AGENDA
PLAN COMMISSION
Board Room, 3rd Floor
Arlington Heights Village Hall, 33 S. Arlington Heights Rd.
Arlington Heights IL 60005
August 27, 2025
7:30 PM

- B. 1455 W. Cellular Dr. - Amazon Additional Buildings - PC25-015
Amendment to PUD Ordinance 04-028 to allow more than one building on a single
lot, Variation

OVERALL SITE PLAN

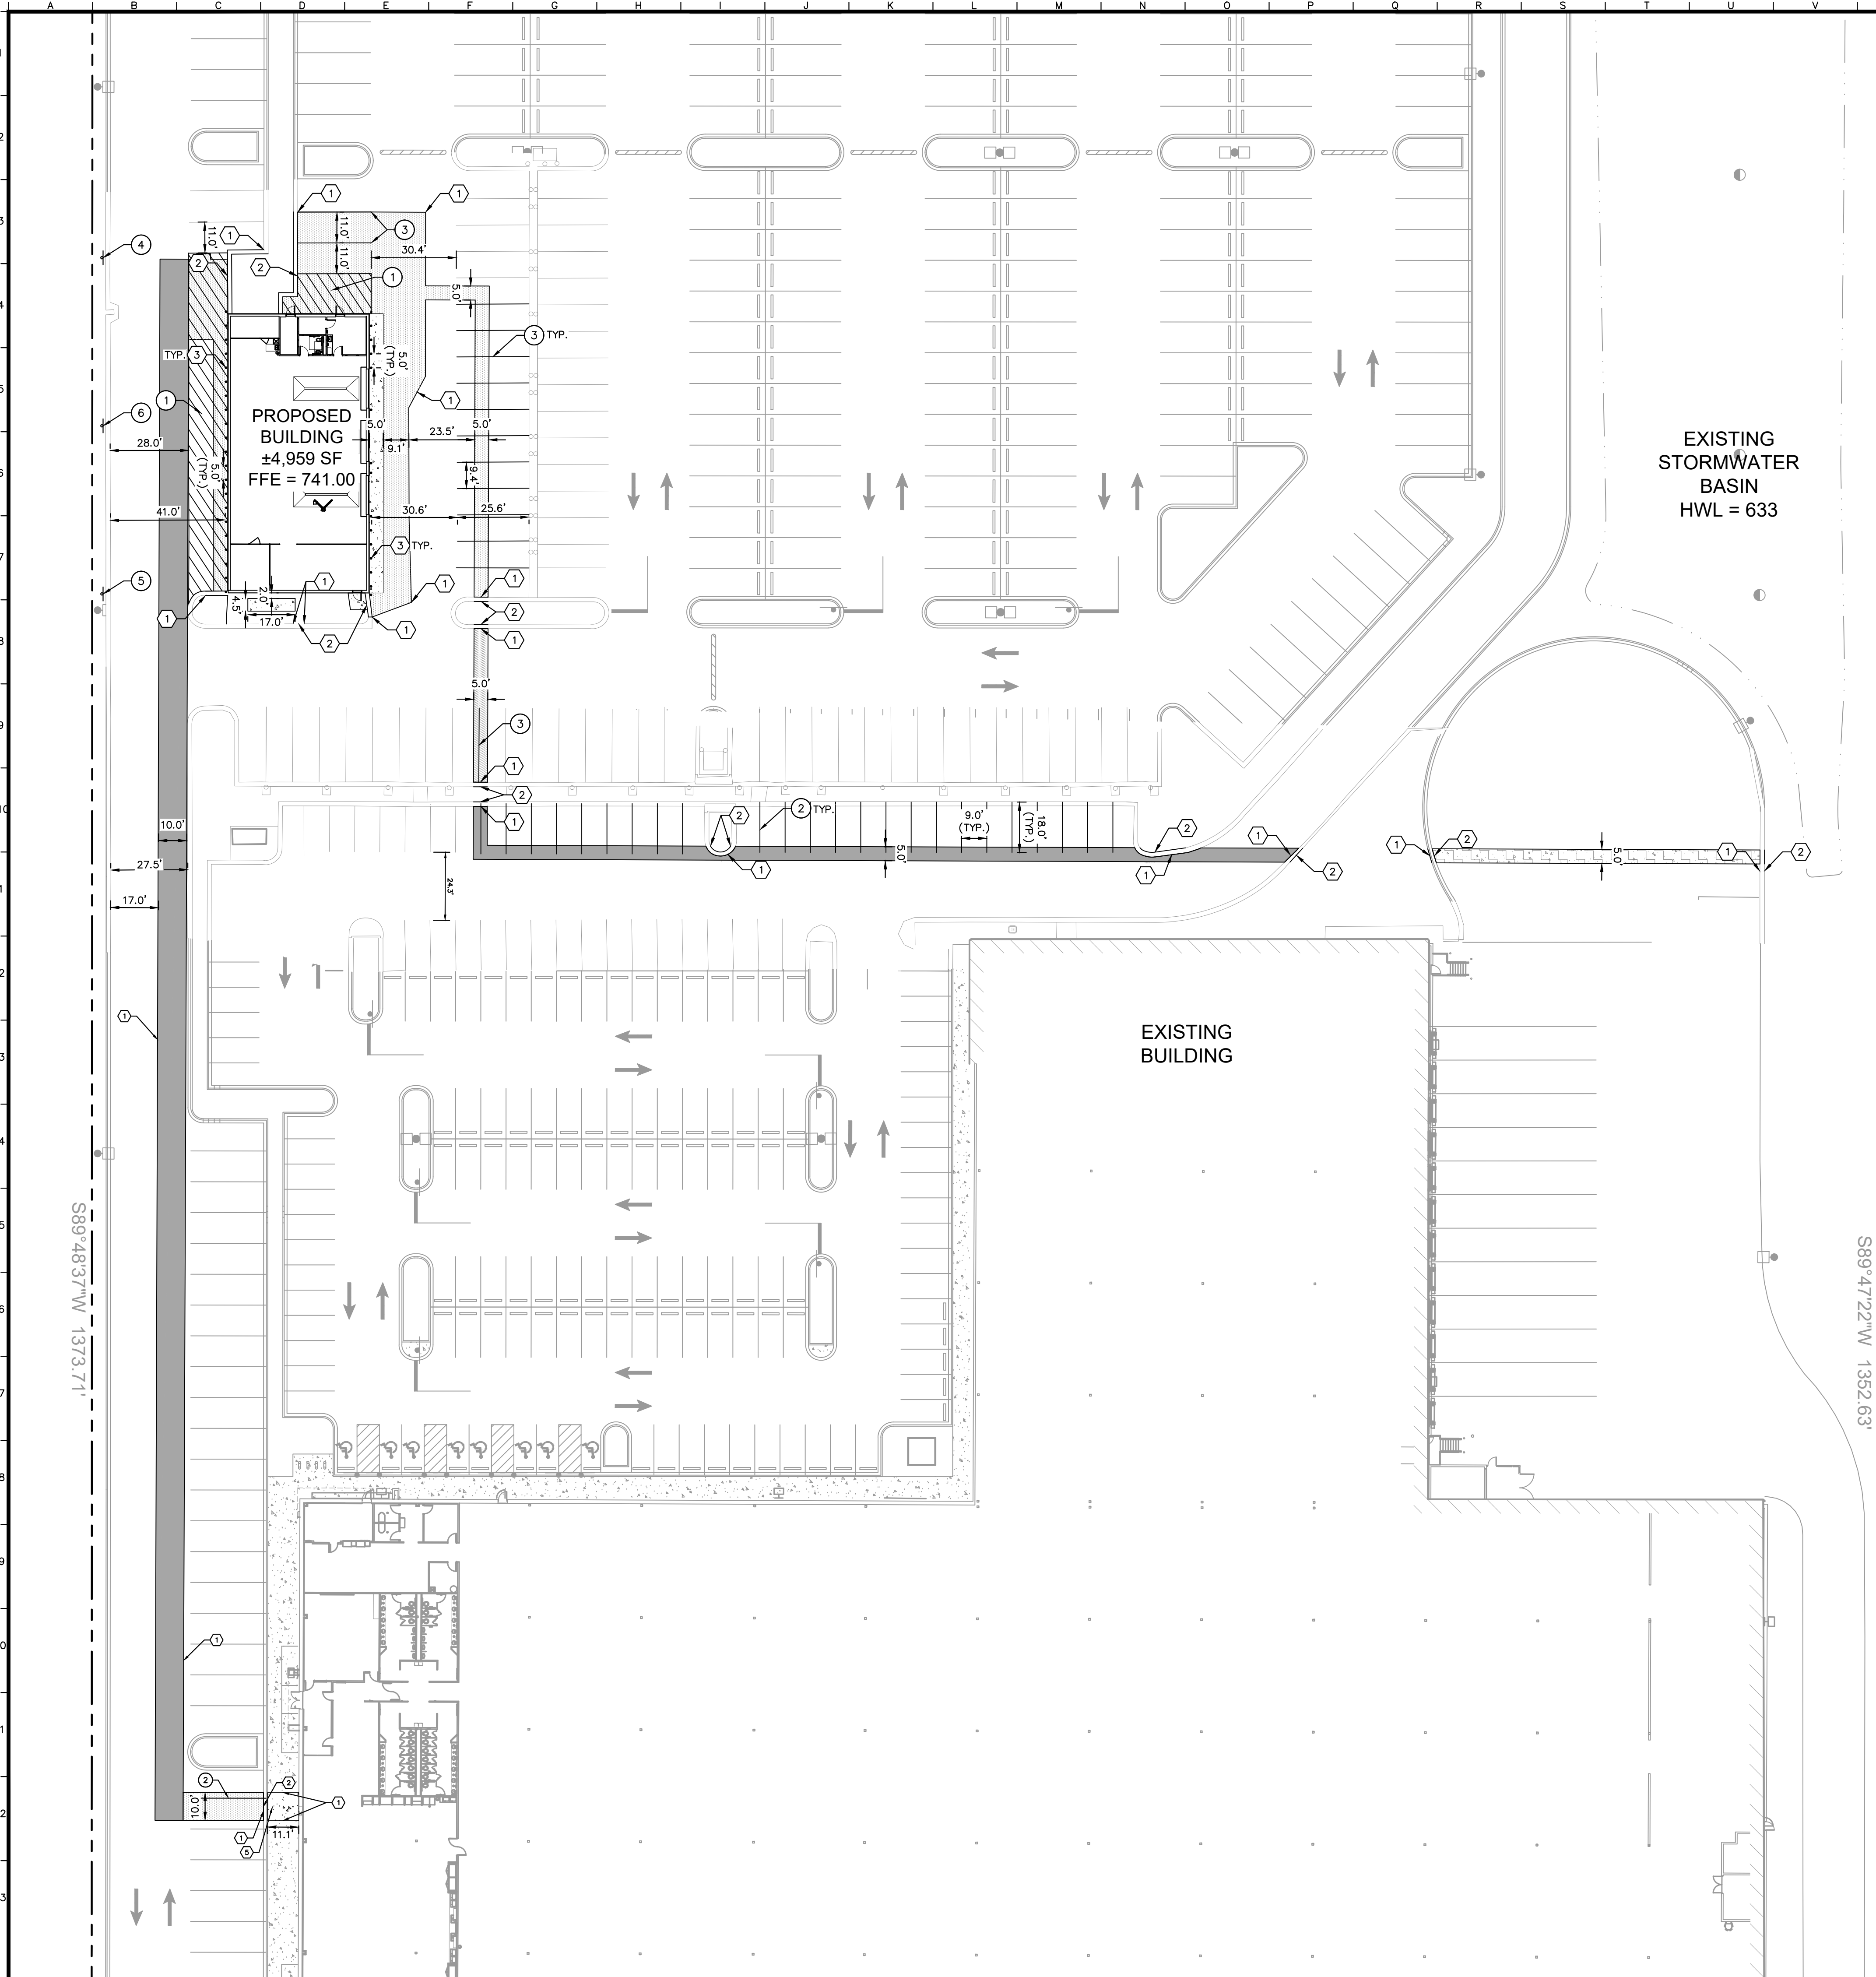
Response: The requested signs have shown on the Fire Access Plan and in the Final Engineering Plans for both the AVI and FSC on the Site Plans (Sheet C2.1).
